**Loudoun County Public Schools
HS-7 Dulles South and Elementary School
ZMAP 2010-0001, SPEX 2010-0003
Response to Referral Comments
June 8, 2010**

Zoning Administration
Comments dated March 29, 2010

SUBJECT: Response to Comments for Loudoun County Public Schools
HS-7 Dulles South High School and Elementary School, Goshen Road Assemblage
(1st Submission) Loudoun County Plan Number ZMAP 2010-0001 and SPEX 2010-0003

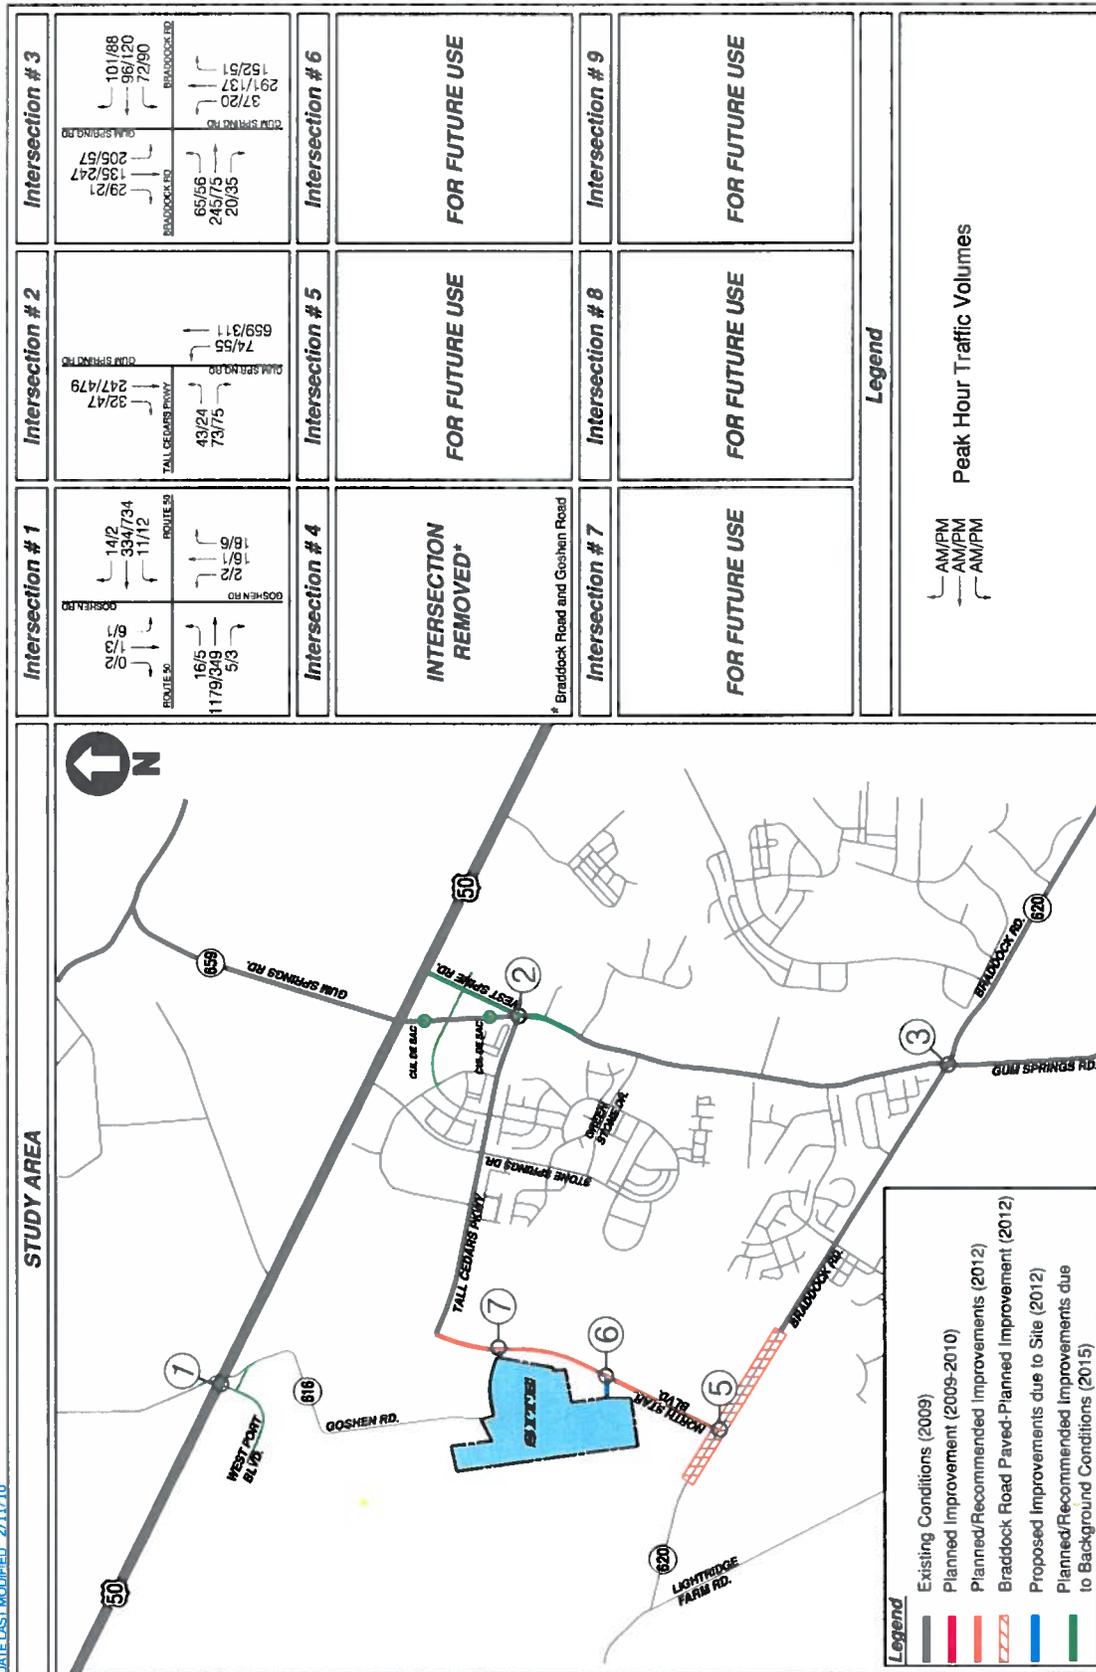
- 4) *Page 23, Figure 8, intersection # 1; Westbound through AM peak volume is shown as 451 and 384 used in synchro analysis. Also, page 35, Figure 14, intersection # 7; Eastbound AM peak through volume is shown as 19 and used 19 in synchro. Should it not be 9? Please verify and correct accordingly.*

The westbound AM peak through volume at intersection #1 should be 384 trips and not 451. The previously submitted Synchro files and capacity analysis are correct. The typographical error in Figure 8 has been corrected in the revised traffic study.

The eastbound AM peak right turn volume at intersection #7 (Figure 14) should be 19 and not 9. The eastbound AM peak right turn volume at intersection #7 (Figure 12, page 33) should be 19 and not 9. This was a typographical error and has been corrected in the revised traffic study.
